September 7, 2021

RE: **Lot 19 Block 8 S.A.D. 227 Unit 5**
6823 Rimrock Dr. NW
Grading and Drainage Plan
Engineers Stamp Date 9/6/2021 (D10D024)

ENGINEER'S SEAL  9/6/21 DAVID SOULE P.E. #14522	6823 RIMROCK	DRAWN BY: WCVJ
	GRADING AND DRAINAGE PLAN	DATE: 9-02-21
 1606 CENTRAL AVENUE SE SUITE 201 ALBUQUERQUE, NM 87106 (505) 872-0999		210210083-LAYOUT-8-02-21
		SHEET #
		JOB # 21021083

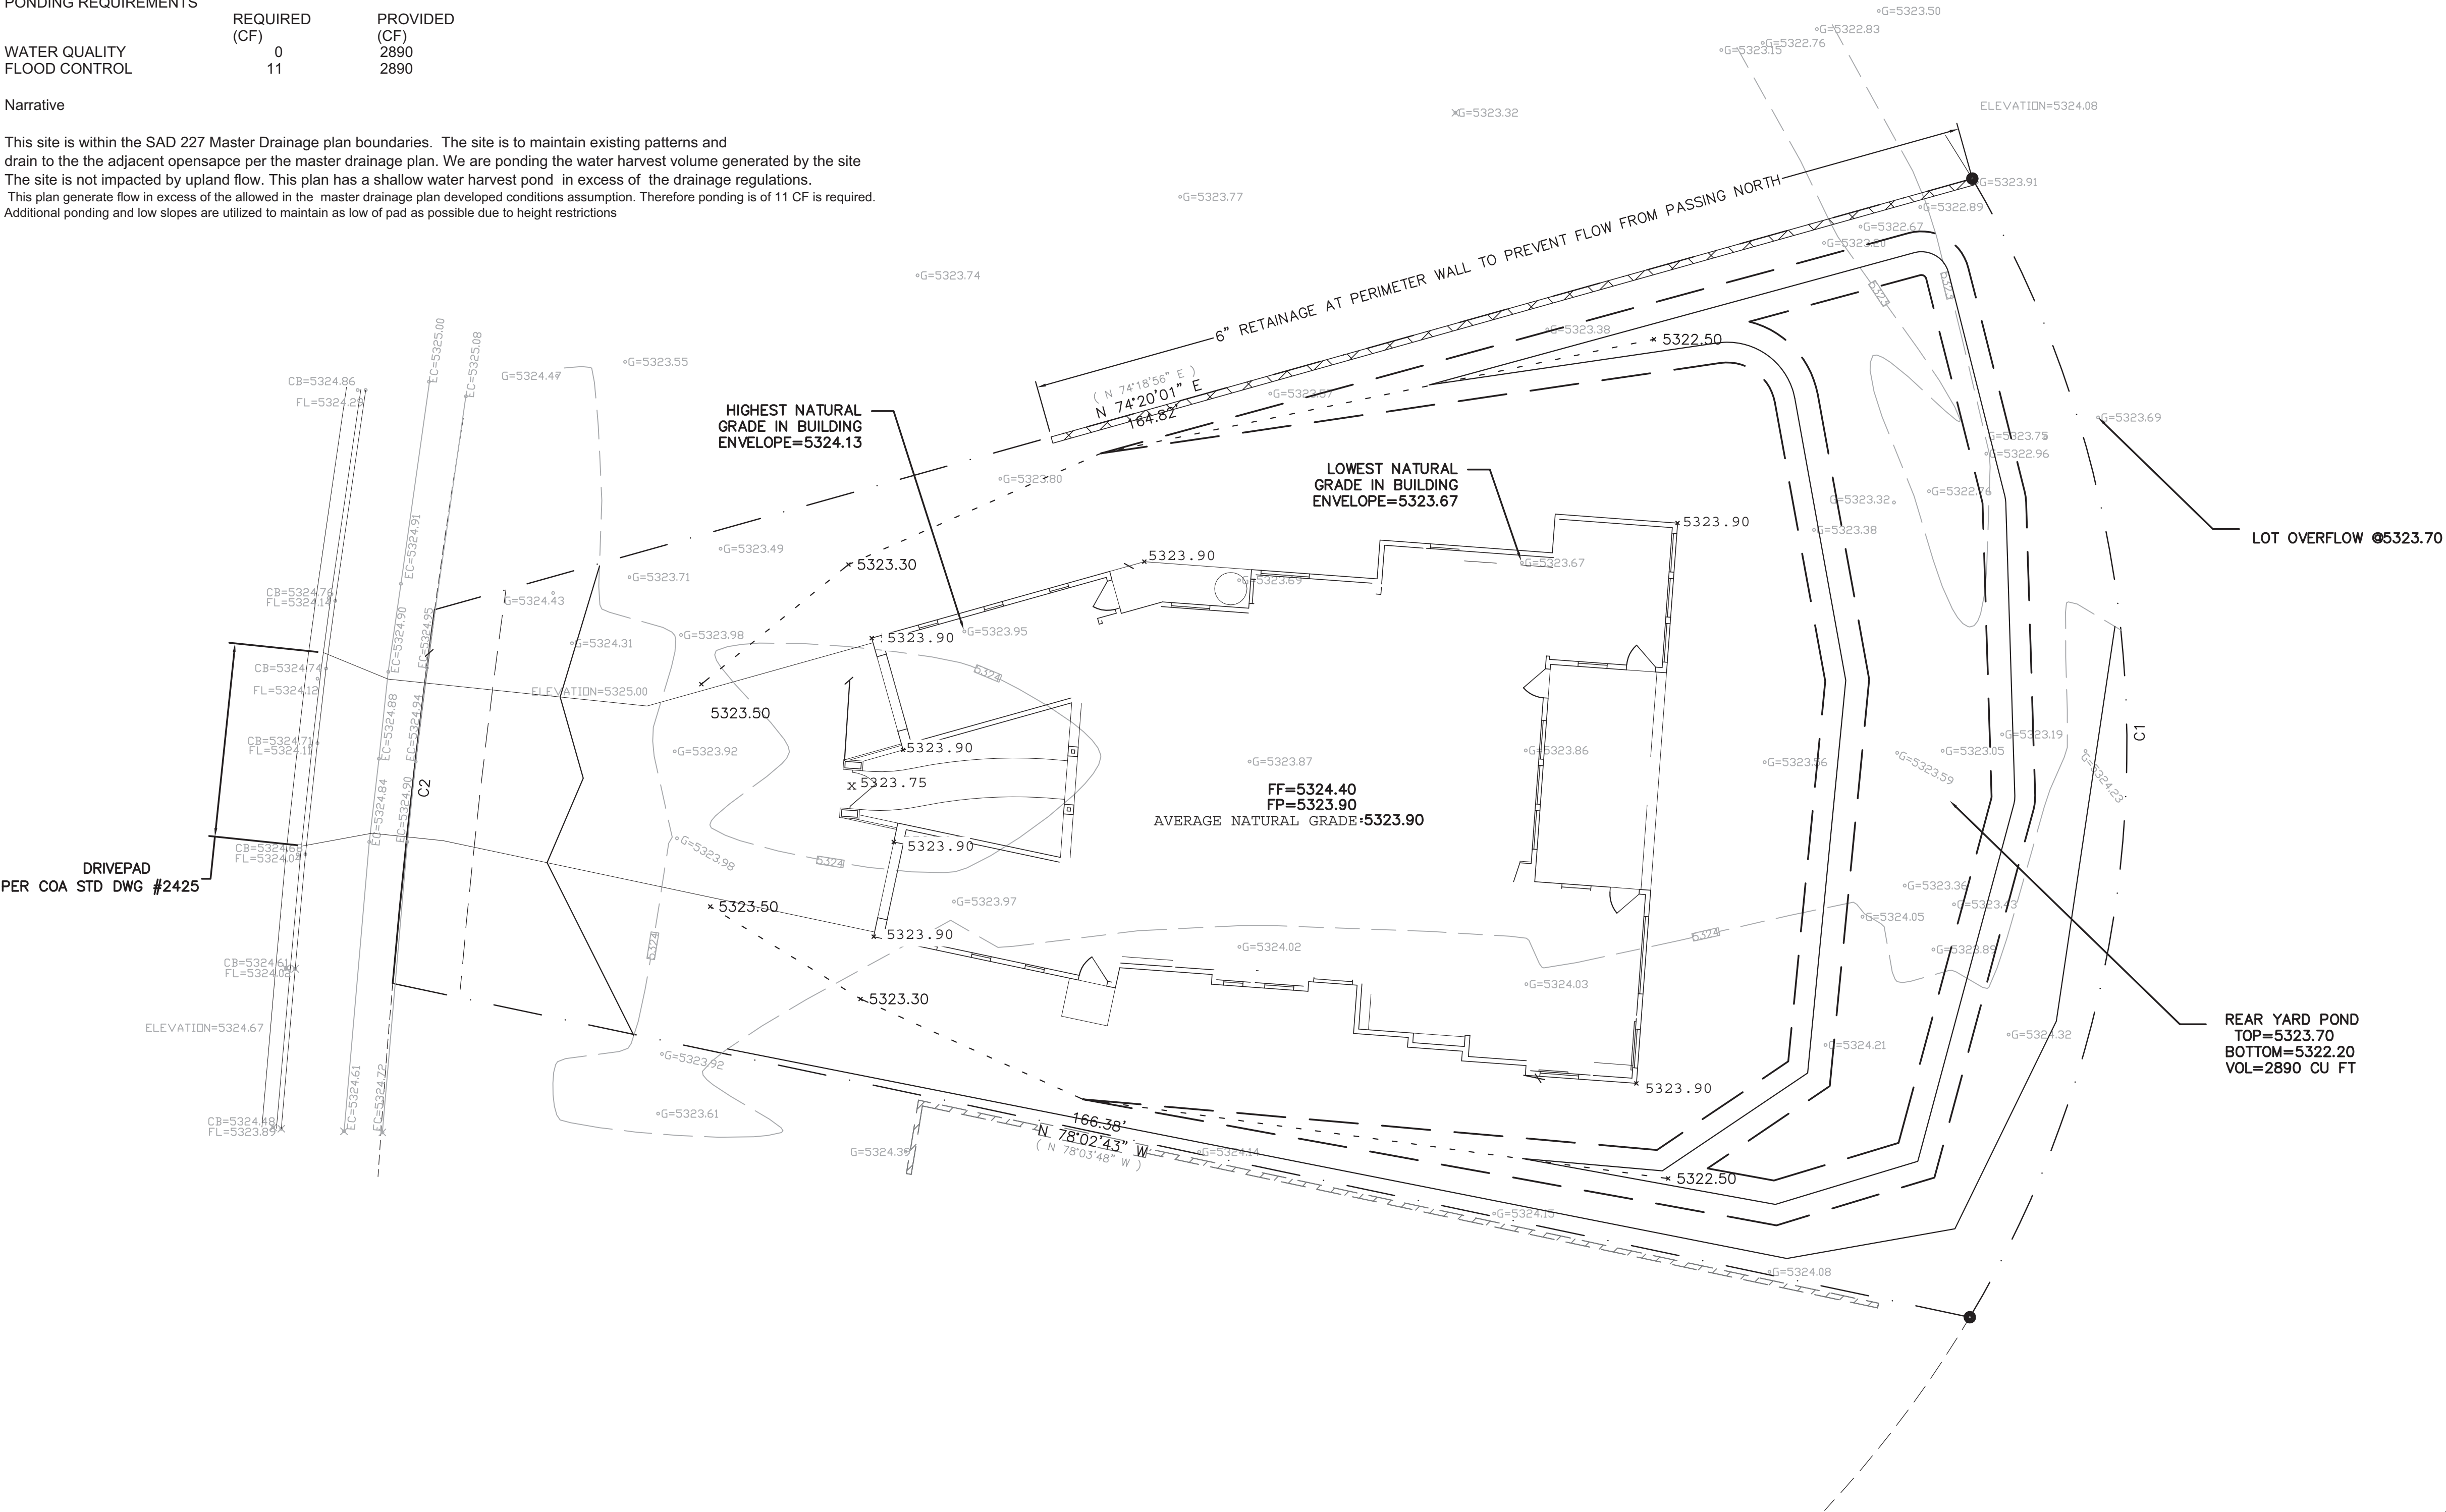
Based upon the information provided in your submittal received 9/7/2021, this plan is approved for Grading Permit. Please inform the builder/owner to attach a copy of this approved plan and letter into the construction sets in the permitting process prior to sign-off by Hydrology.

Reiterate to the Owner/Contractor that a separate permit for any garden/retaining wall must be obtained, with the approved G&D plan. Advise the owner contractor not to use dirt as a ramp to climb the curb, use lumber or crusher fines for this purpose.

Also, let the owner/contractor know that if a pool is to be added in the future the G&D plan will need to be modified showing the location of the pool and the land treatment differences.

Prior to Building Permit approval, a **Pad Certification** will be required. Inform the contractor/owner not to pile dirt in the street as a ramp to climb the curb. If dirt is found in the street the pad cert. will be denied.

Prior to **Certificate of Occupancy release**, Engineer Certification per the DPM checklist of this plan will be required.
